3/31/09	Added General Note (F)
DATE	REVISION	
STATE OF HAWAII DEPARTMENT OF TRANSPORTATION HIGHWAYS DIVISION BRIDGE GENERAL NOTES INTERSTATE ROUTE H-1 EXTENSION AND REPAIR OF SCHOOL STREET ON-RAMP RETAINING WALL Project No. H11-01-08 Scale: As Noted Date: Feb., 2009

3/31/09	Revised and/or Added Callouts and Legend
DATE	REVISION
STATE OF HAWAII DEPARTMENT OF TRANSPORTATION HIGHWAYS DIVISION RETAINING WALL REPAIR and EXTENSION EXISTING SITE PLAN INTERSTATE ROUTE H-1 EXTENSION and REPAIR of SCHOOL STREET ON-RAMP RETAINING WALL Project No. H11-01-08	
Scale: As Noted	Date: Feb, 2009
SHEET No. Q3 OF 34 SHEETS

RETAINING WALL REPAIR and EXTENSION

**WALL "I" DETAILS
WALL "M" and "N" SIMILAR**

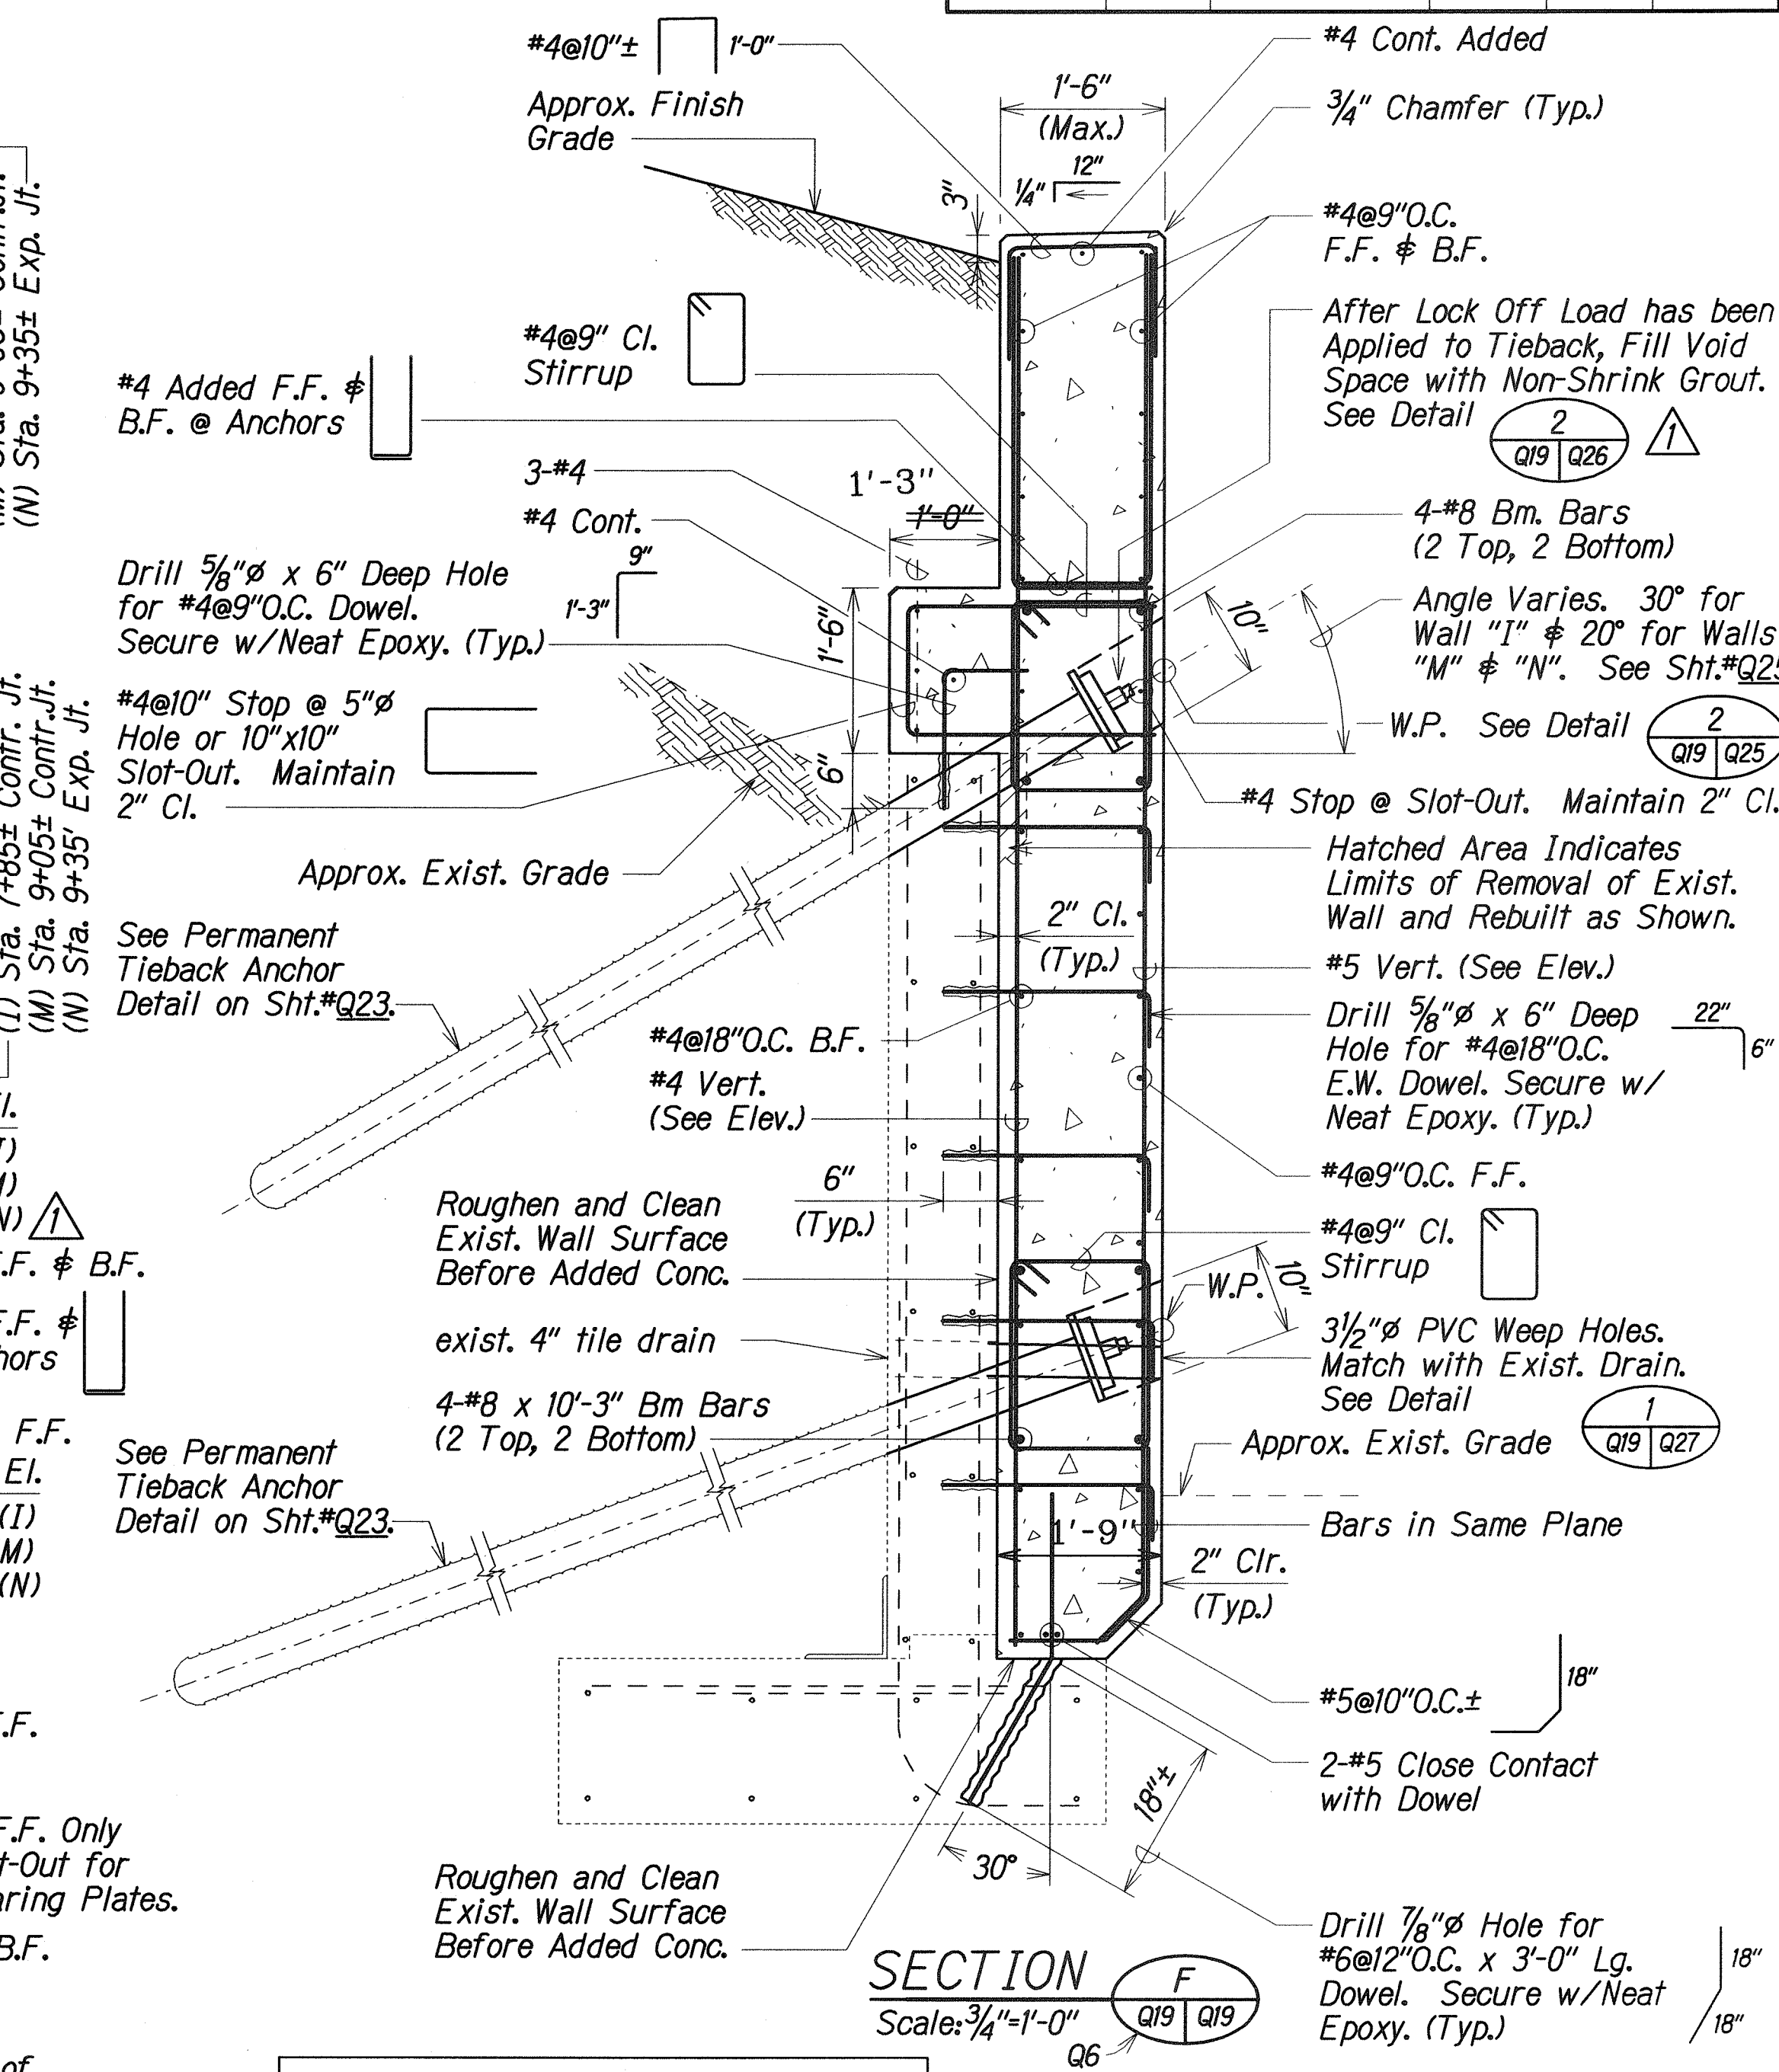
DATE	REVISION
8/17/09	Added Note No. 4, for Wall "M" Only and Added Sheet Number to Detail Symbol
3/31/09	Revised New Wall Elevations (M) & (N), Revised Detail Designation and Hatched Proof Test Anchor

- NOTES:**
1. $\angle$ of All Lower Anchors from Horizontal Shall be 20°.
 2. For Slot-Out Details, See Sheets Q25 & Q26.
 3. For Expansion & Contraction Joint Details, See Sht.*Q7.
 4. Additional Reinf. @ Wall "M" Only, See Sht.*Q25A.

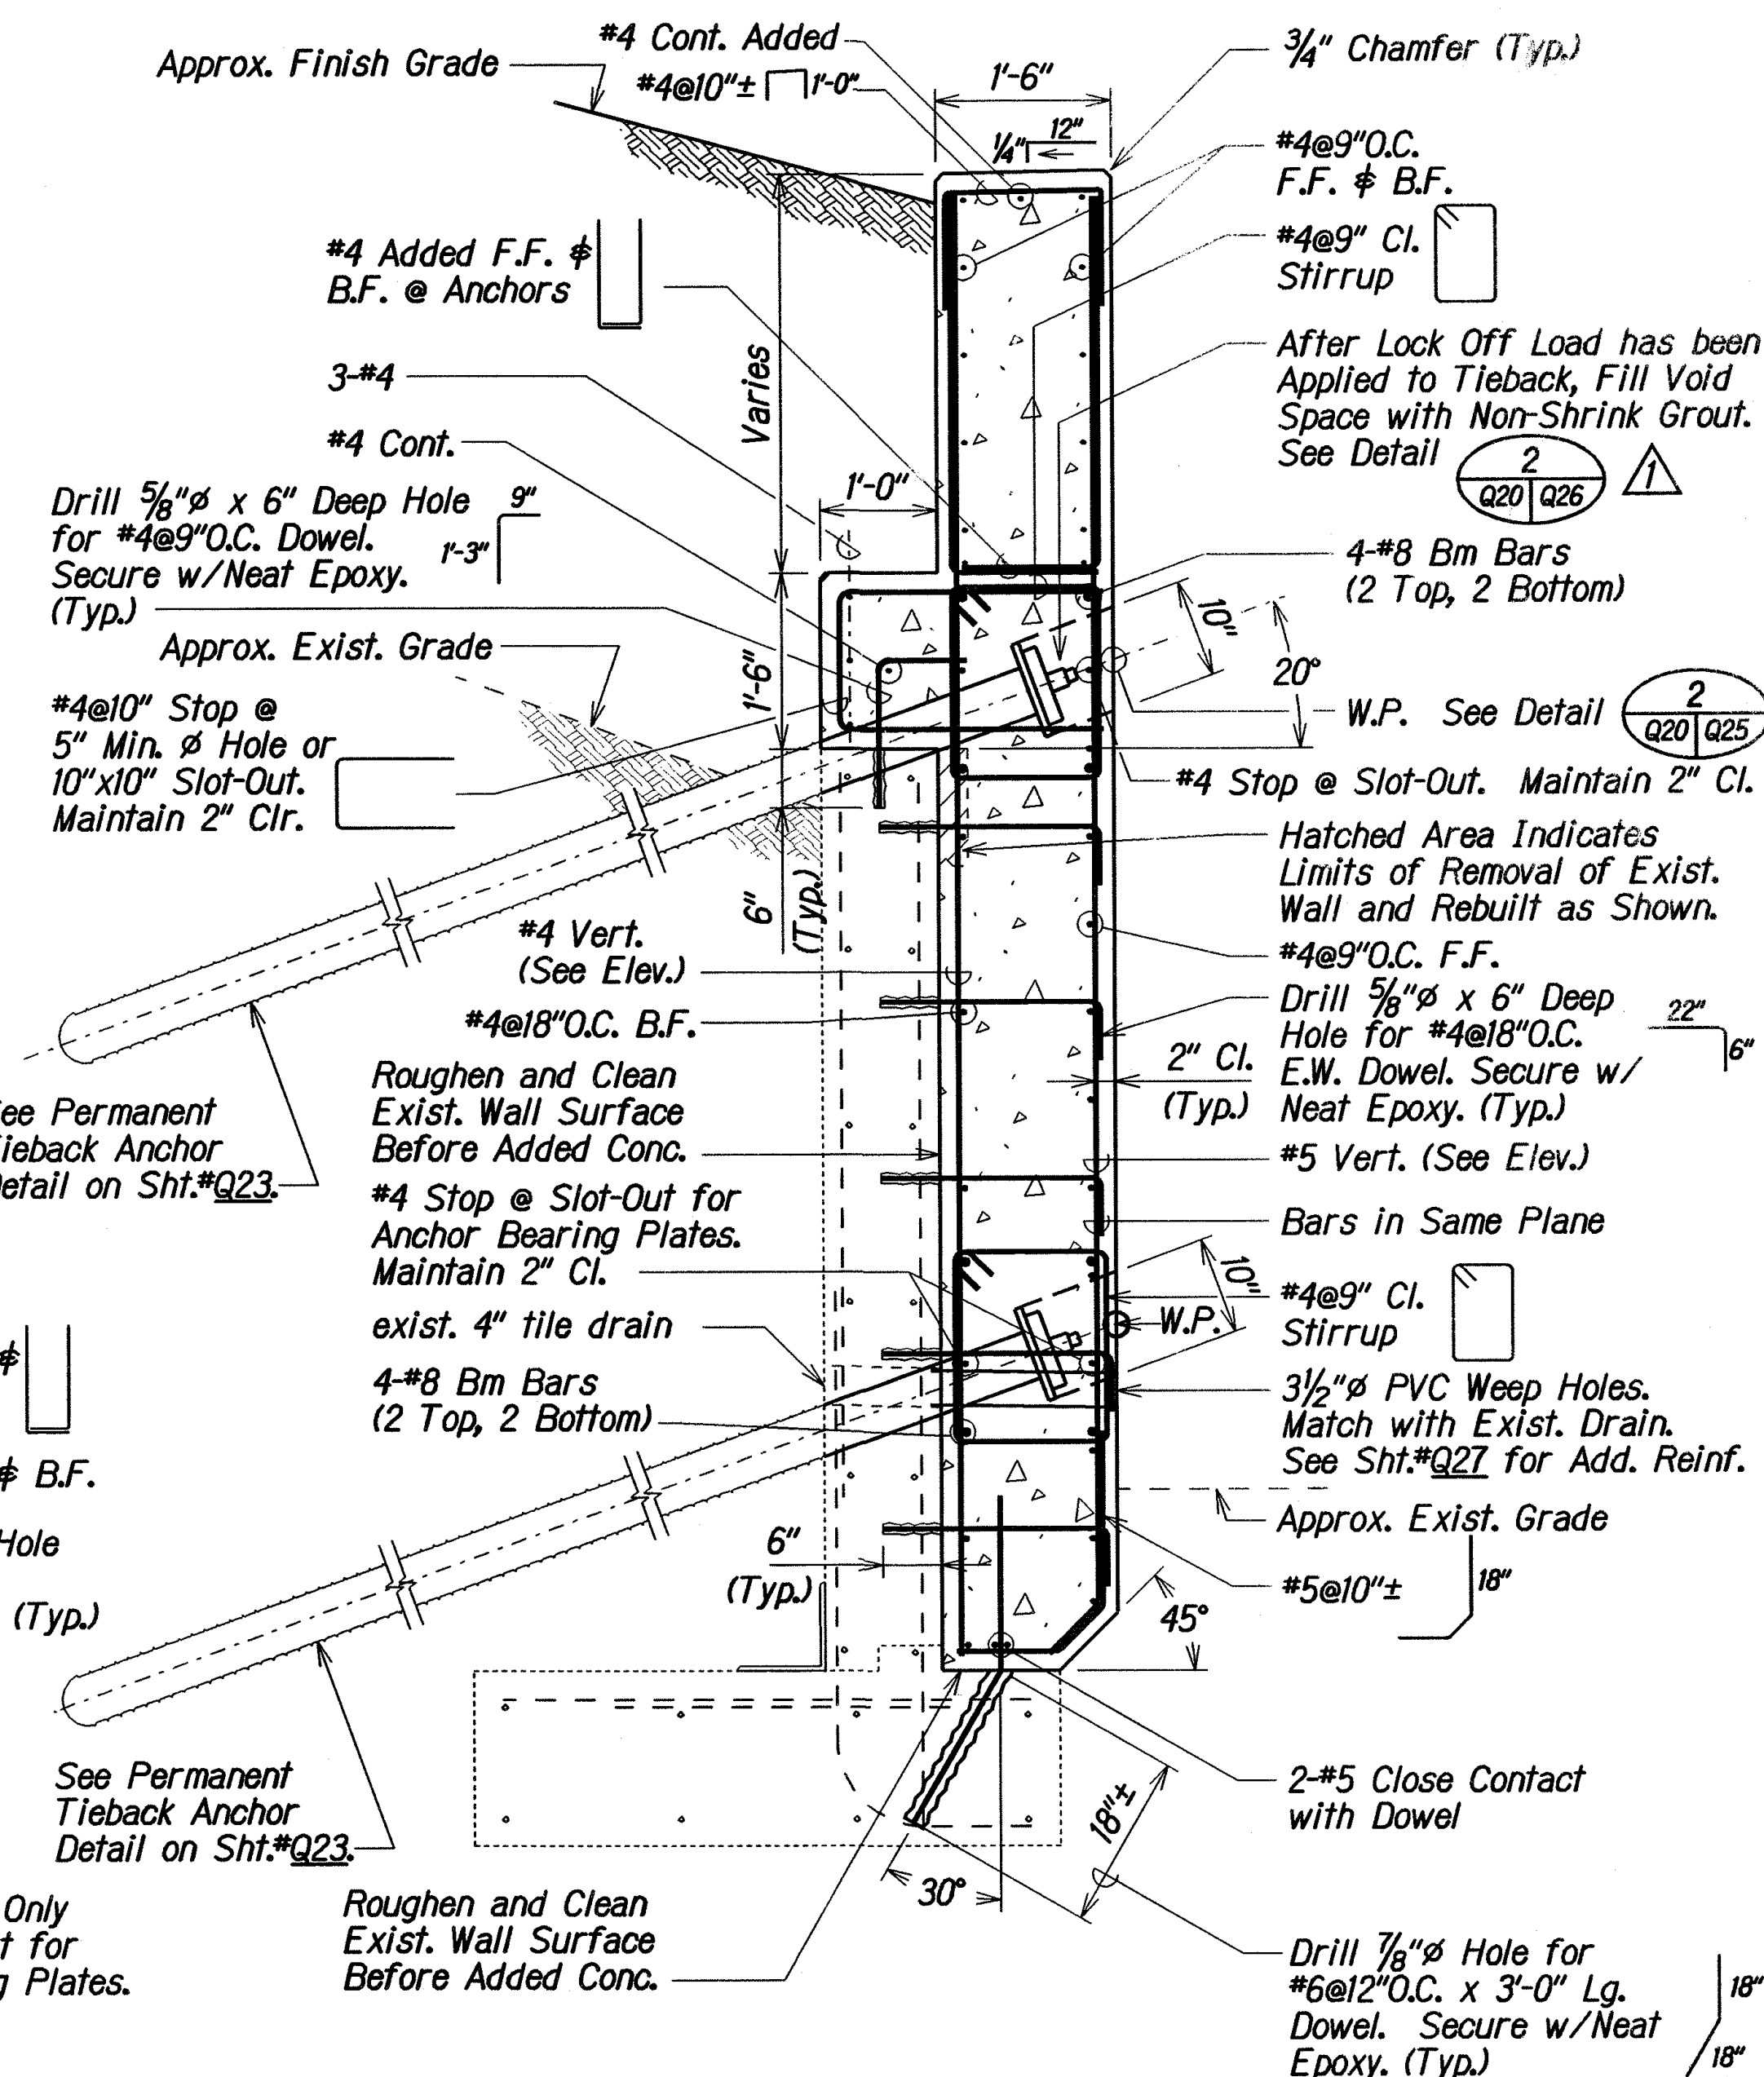
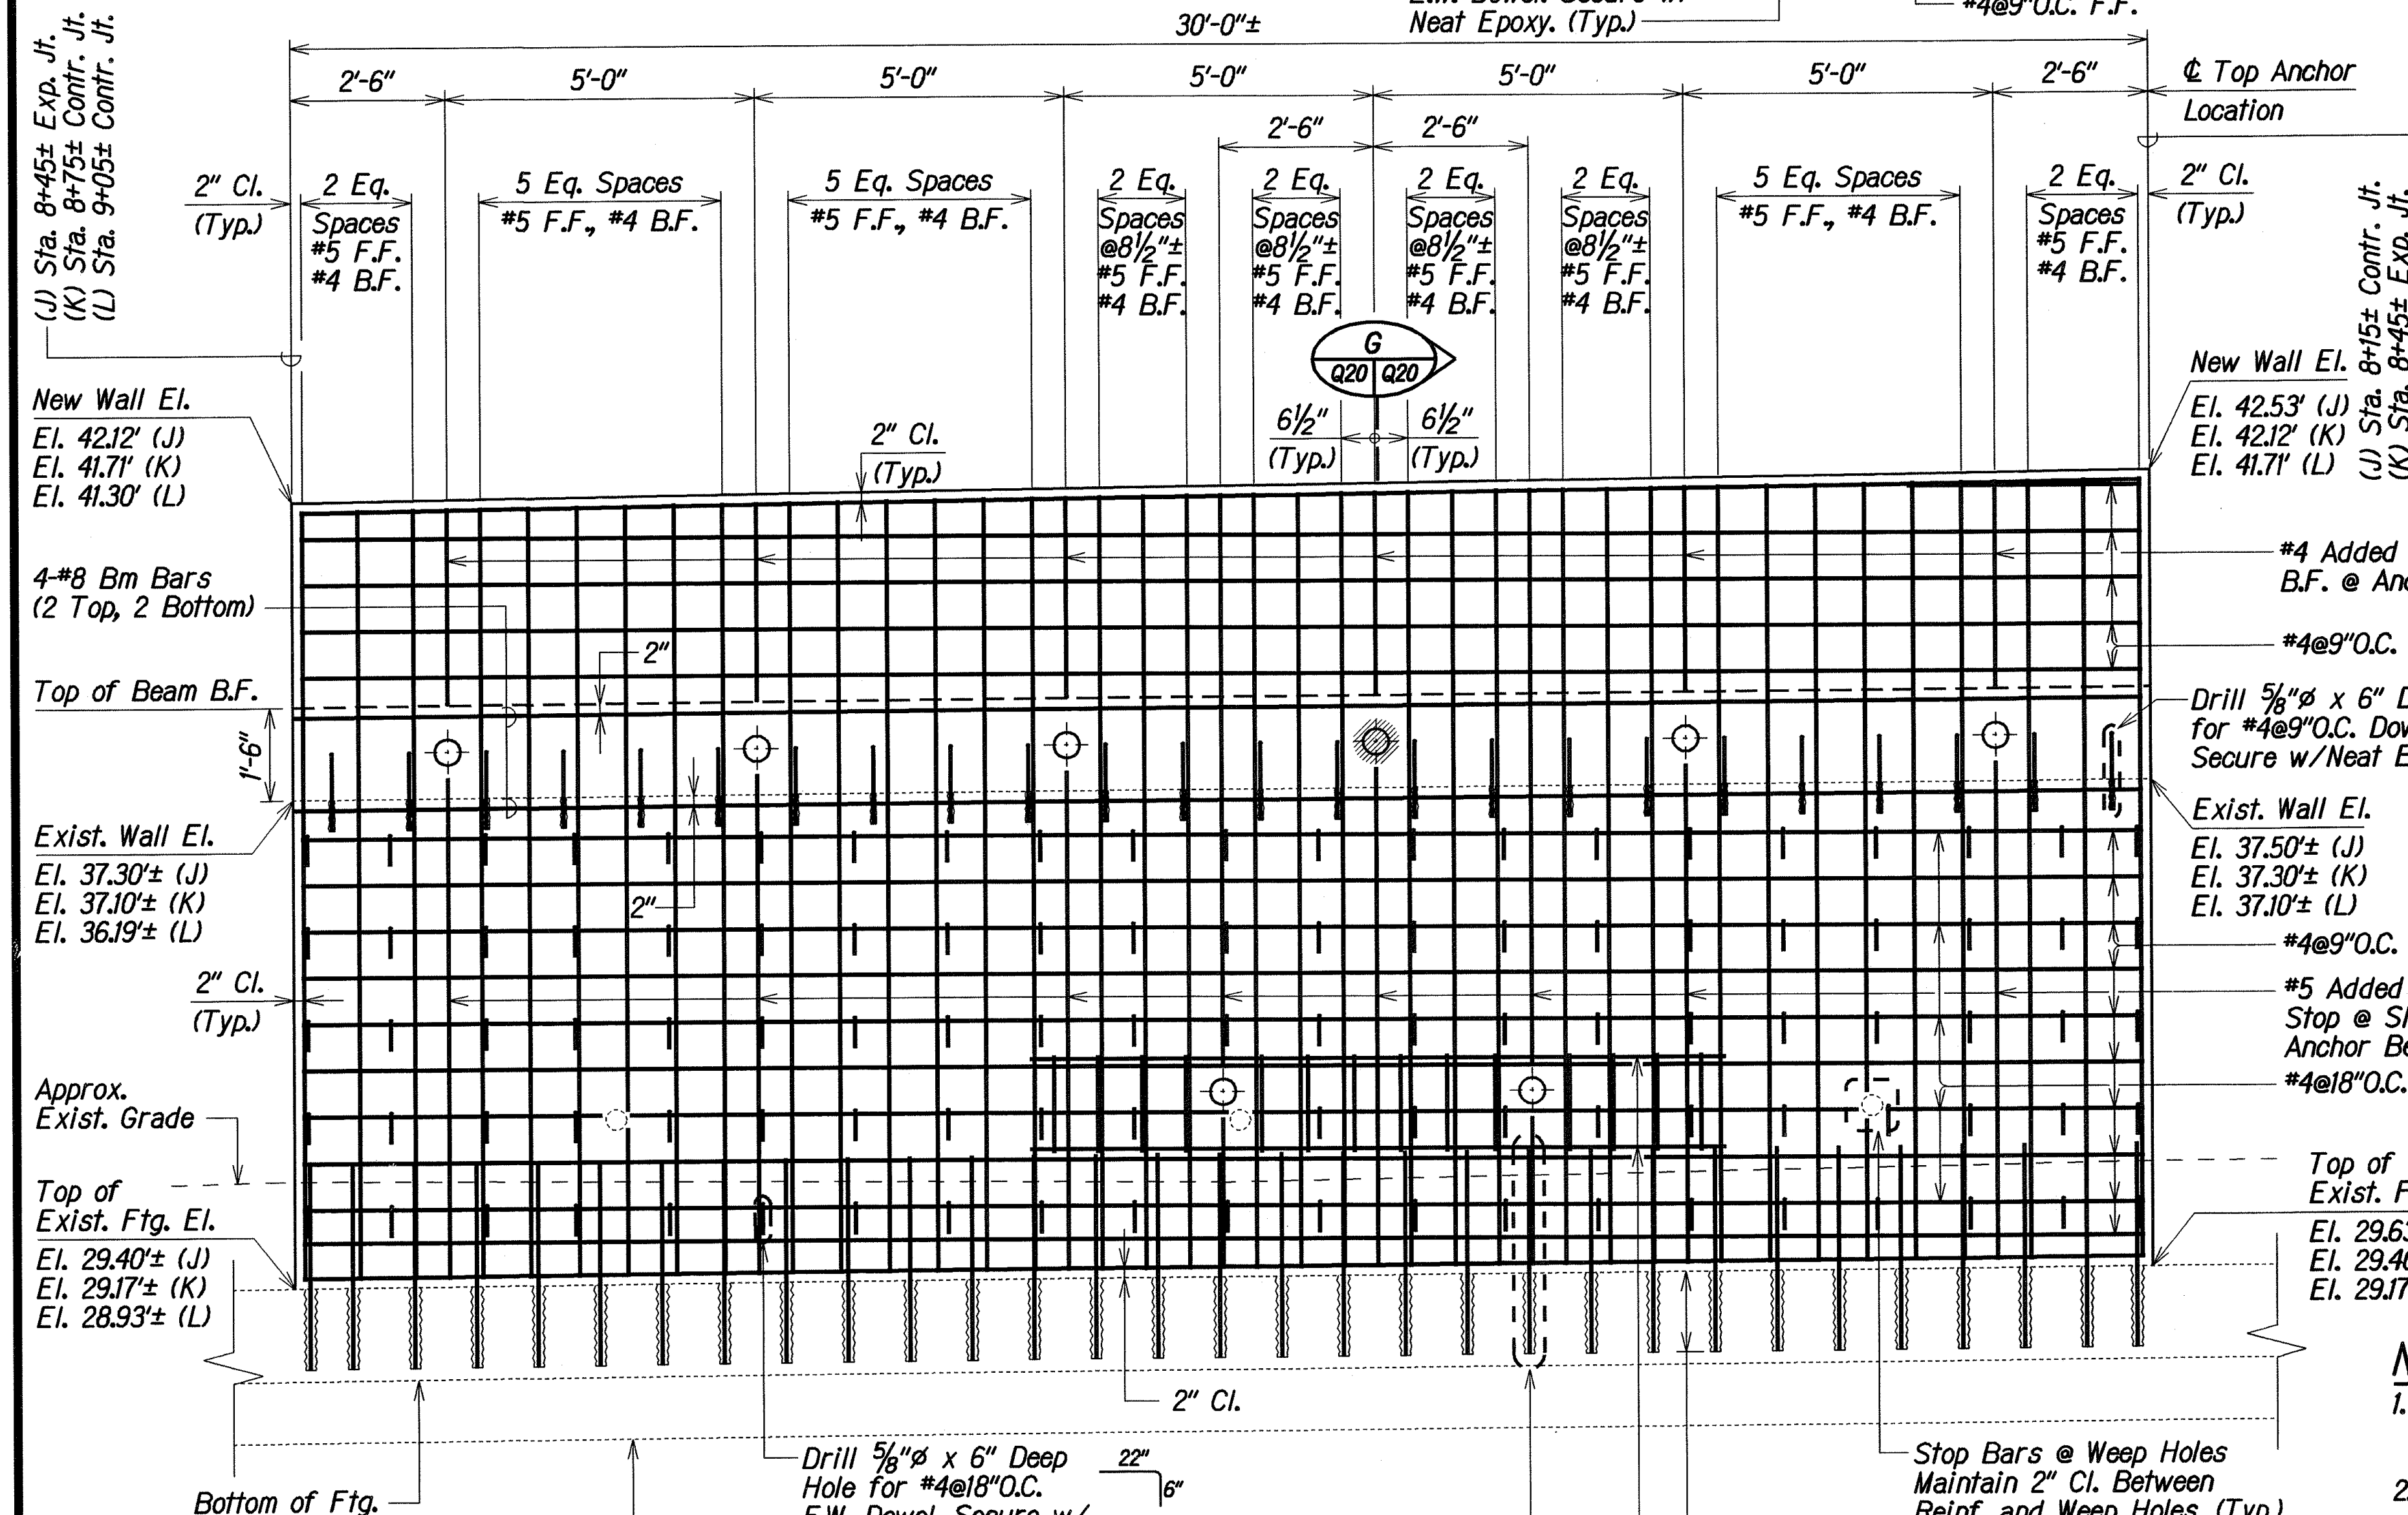
3/31/09	Revised Detail Designation
DATE	REVISION
STATE OF HAWAII DEPARTMENT OF TRANSPORTATION HIGHWAYS DIVISION RETAINING WALL REPAIR WALL "J", "K" AND "L" DETAILS INTERSTATE ROUTE H-1 EXTENSION AND REPAIR OF SCHOOL STREET ON-RAMP RETAINING WALL Project No. H11-01-08	
Scale: As Noted	Date: Feb. 2009
SHEET No. Q20 OF 34 SHEETS
